Recall Bulletin

F/CMVSS NONCOMPLIANCE RECALL

SUBJECT: Passenger Side Instrument Panel Performance

MODELS: 2009-2014 Chevrolet Express
2009-2014 GMC Savana
2500/3500 Series Equipped with Front Passenger Side Airbag (AK5) and
GVWR of 10,000 Pounds (4536 kg) and Below

3785217

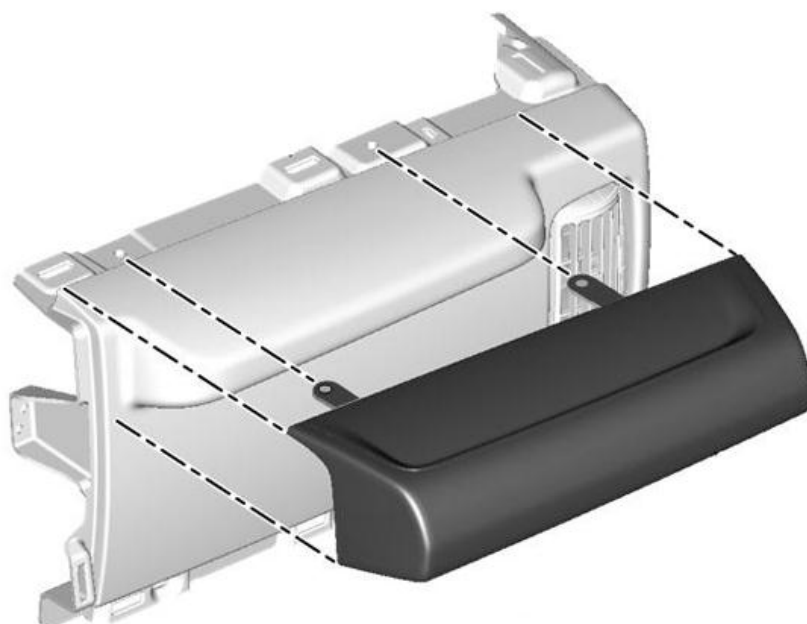
1. Remove the instrument panel upper trim pad. *Refer to Instrument Panel Upper Trim Pad Replacement in SI.*
